<b>DOCKETED</b>	
<b>Docket Number:</b>	18-IRP-01
<b>Project Title:</b>	Integrated Resource Plan
<b>TN #:</b>	230772
<b>Document Title:</b>	City of Santa Clara Silicon Valley Power Comments - Comment on Staff Review of SVP IRP
<b>Description:</b>	N/A
<b>Filer:</b>	System
<b>Organization:</b>	City of Santa Clara/ Silicon Valley Power
<b>Submitter Role:</b>	Public Agency
<b>Submission Date:</b>	11/15/2019 4:57:17 PM
<b>Docketed Date:</b>	11/18/2019

Silicon Valley Power Integrated Resources Plan

**COMMENTS ON THE STAFF REVIEW OF SILICON VALLEY POWER'S  
INTEGRATED RESOURCE PLAN**

Figure 1 –SVP purchases in the California ISO market – Carbon intensity will vary throughout the day and not a static 0.428 MTCO2 default as in the GEAT Standardized Reporting Tables

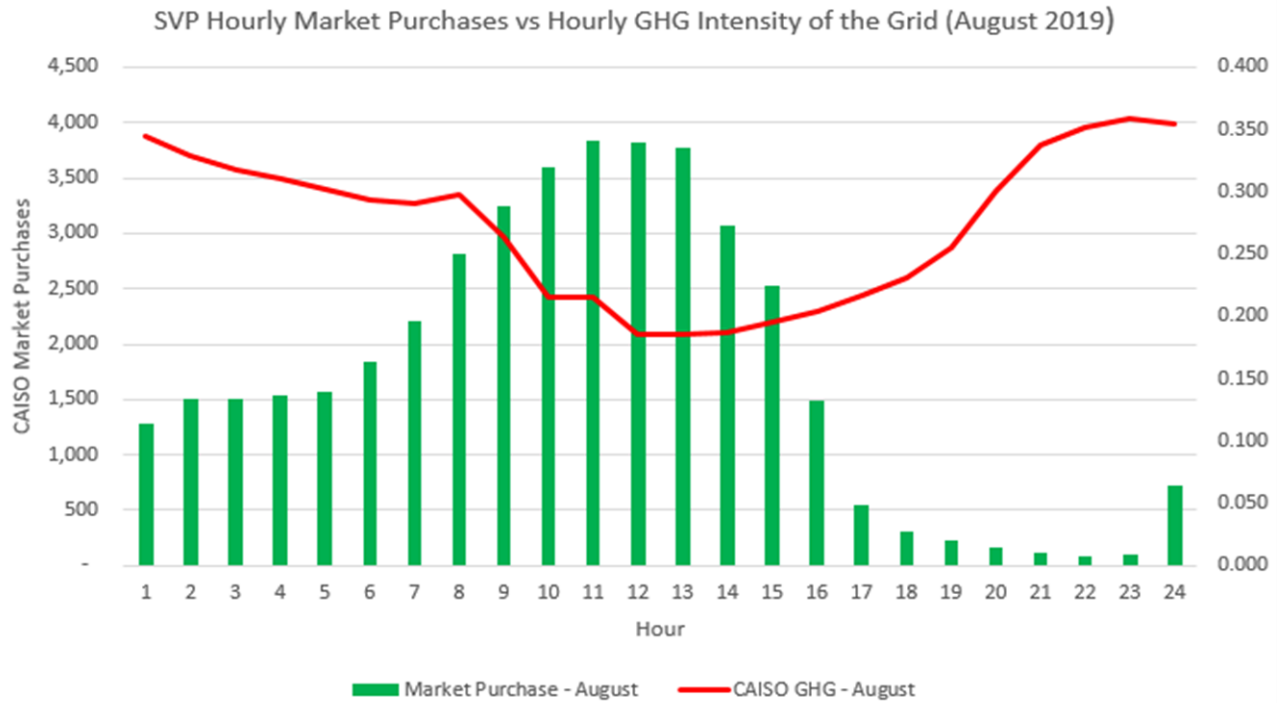
Figure 1 shows SVP's hourly market purchases during the month of August 2019 from the California ISO and the associated carbon intensity of the California ISO grid during the same hour. As shown, the majority of SVP's market purchases during the month of August occurred during the hours where the carbon intensity was at its lowest. Therefore, if the carbon intensity is not accounted for on an hourly basis, the application of the default emissions rate would overstate or understate the true emissions factor for the market purchases.
